22-0266 - 2558 Nashville Highway - Wynnsong Mixed Use PUD

Request from T-Square Engineering for design review approval of new storage unit building within a PUD located at [TAX MAP 42 PARCEL 13](#) off Nashville Highway.

ART 22-0266

PROJECT DESCRIPTION: Self-Storage Facility.

1.2 ELEVATION-SOUTH
SCALE: 1/8"=1'-0"

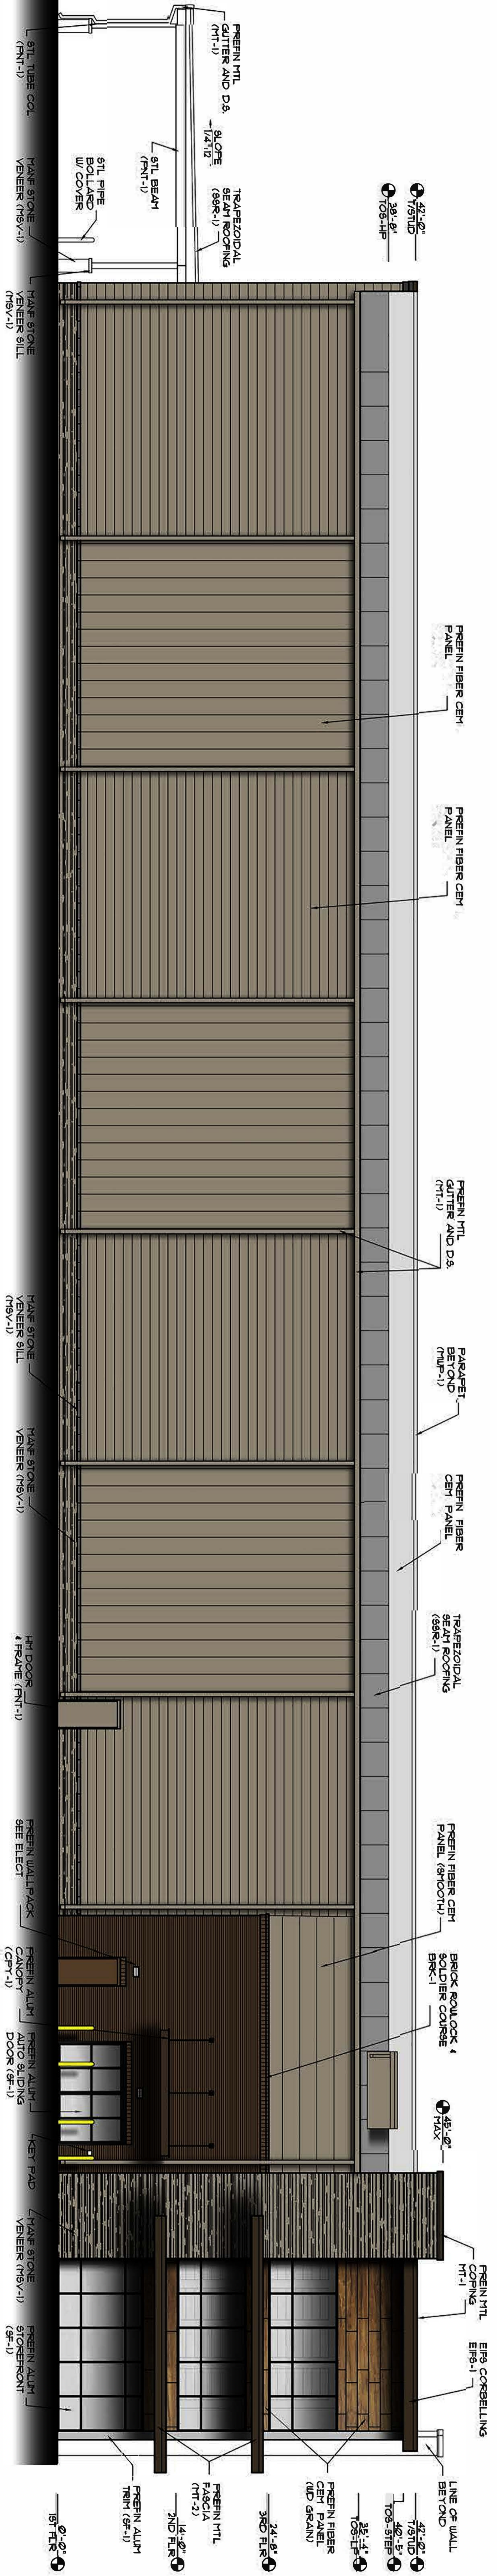
This proposed three story self-storage facility consists of a primary front façade material of fiber cement board accented by brick and stone veneer. Elevations were given for the south and east elevation; however, elevations were not given on additional elevations. Likewise, the south elevation that is visible would require articulation every 35' as highlighted in section 6.1 described above.
